Memorandum

To: Tom Jacobson, EKN Development Group
From: Rob Brueck
Date: October 14, 2022
Subject: Scenic Quality Evaluation of Lake Tahoe Hotel & Residences
(formerly Boulder Bay) Project Revisions

Lake Tahoe Hotel & Residences Project Revisions

Figure 4: Viewpoint 13 from SR 28 and Stateline

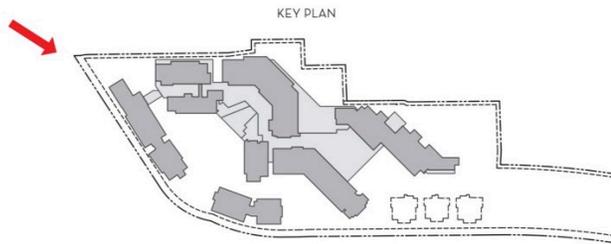
At viewpoint 13 (SR 28 and Stateline) the casino façade (building E on left side of the image) is closer to the viewpoint location in the revised plan and somewhat wider and taller. However, neither the 2009 or current building design block views of a mapped TRPA scenic resource or ridgeline from this viewpoint, and both offer an improvement to building setback from the roadway, architectural style, and landscaping as compared to the existing Biltmore structure. At viewpoint 14 (Biltmore parking lot from SR 28), the revised location, size and architectural design of buildings G and H will continue to provide views through the project site of the ridgeline to the west and improve manmade features by replacing existing surface parking and retaining walls with buildings and landscaping that are consistent with Area Plan community design goals.

Figure 7: Viewpoint 16 from Lake View Avenue

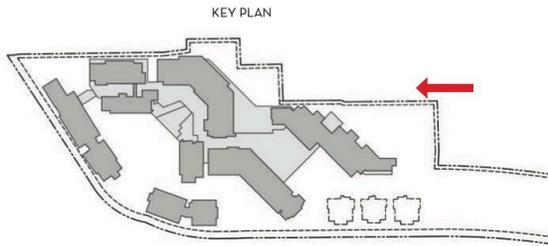
At viewpoint 16, the simulation for the revised Project is consistent with the building height and massing proposed in the 2009 DEIS. From this Lake View Avenue viewpoint located above the Project in the residential neighborhood, the proposed buildings will not obstruct views to Lake Tahoe nor the ridgelines beyond.

Figure 8: New Viewpoint Looking North on SR 28

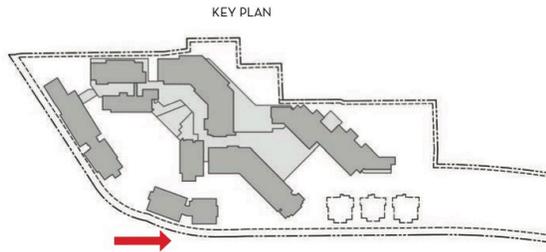
A new viewpoint (Figure 8) was added for this analysis to document potential changes to viewpoints while traveling north on SR 28. As shown in this new viewpoint location, existing vegetation that is proposed to remain within the SR 28 right of way along with proposed landscaping within the pedestrian corridor provides effective screening of proposed buildings (e.g., buildings G and C) and the south side of building A. As such, the existing vegetation shown in the simulation (highlighted in green) shall be protected and maintained in this location. A review of the site plan confirms that these four evergreen trees are healthy and will not be damaged during grading for utilities or the building G site preparation. Each of the trees is on the SR 28 side of the proposed pedestrian walkway and over 20 feet from the building G foundation.

The two story volume of building G is described screen intermittently by landscape elements and trees. Included in this view are the pedestrian improvements along the SR 28 frontage.

The larger trees anchoring the building C amenity area help screen the volume of the building beyond.

1. Additional landscaping, consisting of taller evergreen trees, shall be required on each side of the park access roadway to improve screening of the building A ground level floors as viewed from the SR 28 viewpoint 15 (see areas highlighted in green on Figure 9 and the simulated planting plan on Figure 6). These trees shall be included on the Project landscaping plan for TRPA review and approval as part of the Permit Revision process.
2. Existing vegetation located adjacent to building G consisting of four conifer trees within or near the SR 28 right of way and shown in the photo simulation (see trees highlighted in green in Figure 8) shall be protected and maintained as part of the Project plans.
